LAND REAR OF CHURCH ROAD, WORTHENBURY PLANNING APPLICATION – P/2021/0032 CONSULTATION RESPONSE

TITLE:
PROPOSED WASTEWATER
OUTFLOW LOCATION PLAN

DATE: 17/01/22	SCALE @ SIZE: 1:750@A3	DRAWN: HB	CHECKED: MB
PROJECT No: HE0899		DRAWING No: 100	
		REV: A

Figure 1: Proposed Wastewater Outfall Location (Betts Hydro, 2022)

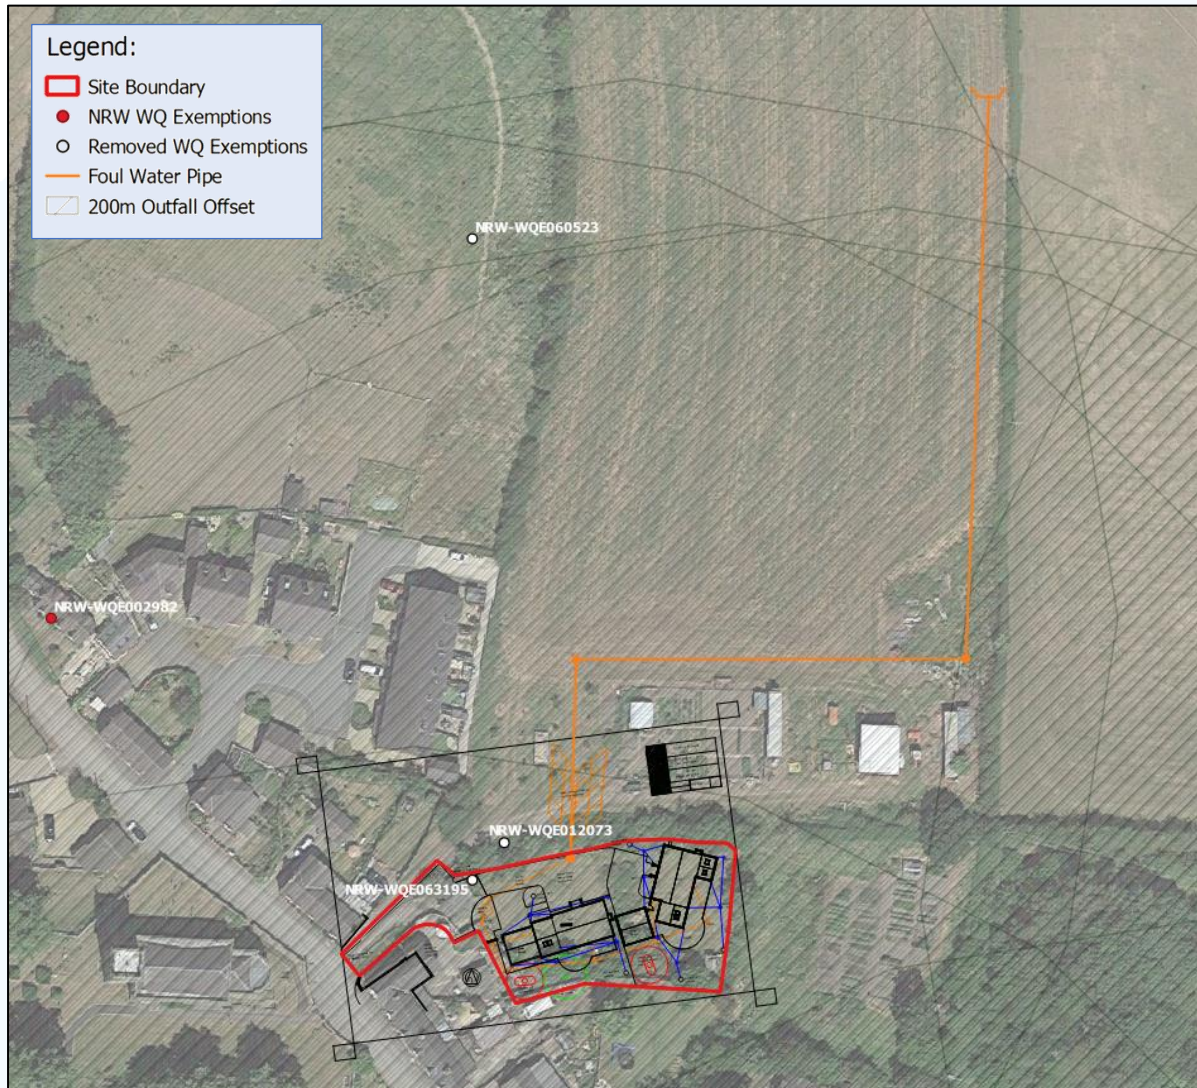
(see plan in **Appendix B**). A new location has therefore been proposed for the wastewater outfall, as shown in **Figure 1**. To identify the proposed location for a suitable outfall, the "NRW_DS123318_WQ_Exemptions" dataset provided by NRW was reviewed. Initially, an outfall into the field adjacent to the northern boundary of the site was not possible due to the presence of three existing points of discharge to ground.

The following points were however removed before calculating the 200m outfall offset in relation to the development proposals:

- NRW-WQE063195
- NRW-WQE012073
- NRW-WQE060523

Points NRW-WQE063195 and NRW-WQE012073 were removed as discussion with the client have identified that these points are to be replaced by the new wastewater treatment system as part of the development proposals. The third point of outfall (NRW-WQE060523) identified north-west of the development proposals has also been removed as further discussion with Matthew Phillips and Emma Broad at Wrexham County Borough Council, and John Done who owns the four-acre field gave NRW permission to move the outflow so it was not located within proximity to any other discharges to ground.

With the removal of the three points of outfall, a suitable location was identified within the north-eastern corner of the field located adjacent to the northern boundary of the site. It is understood that this location is policy compliant as it is not located within 200m of another point of outfall.

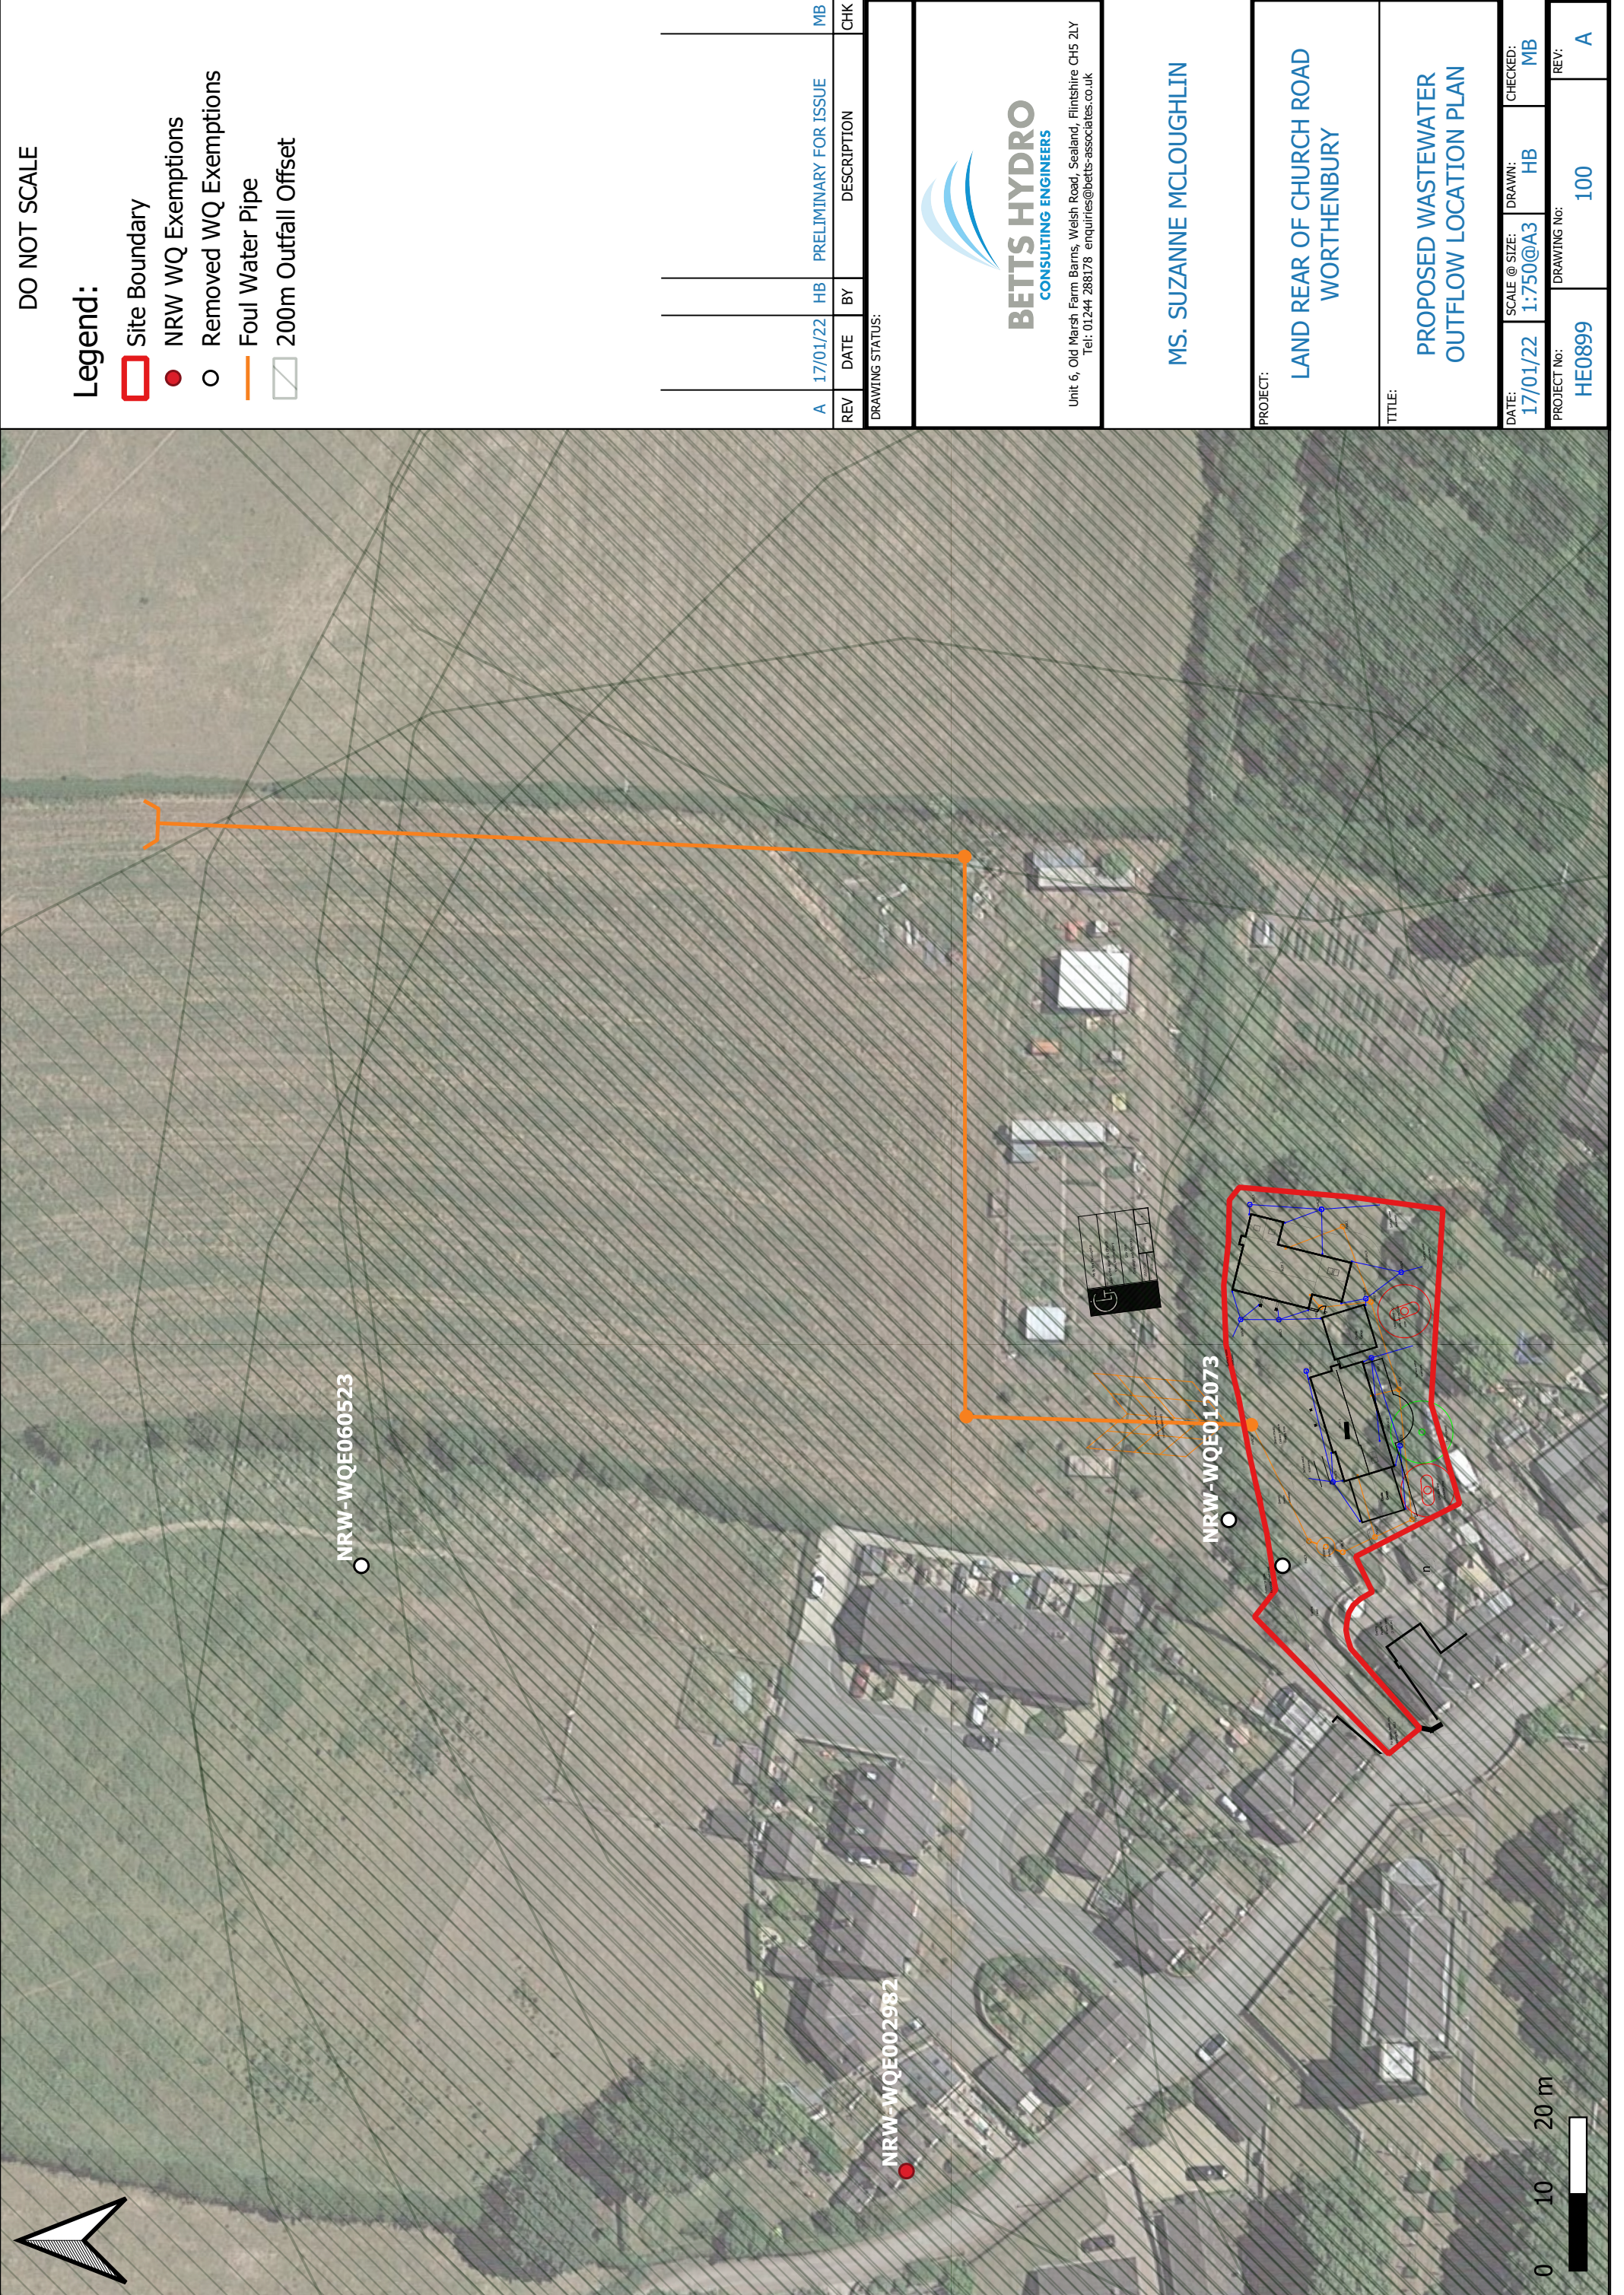
In relation to point 3, we would advise that an updated plan should be submitted to the Local Planning Authority in order to provide confirmation of the location of the proposed drainage field. However, in principle, we can confirm that provided there are no other discharges to ground within 200m of the location, the application should screen out in accordance with our [Advice to planning authorities for planning applications affecting phosphorus sensitive river Special Areas of Conservation](#).
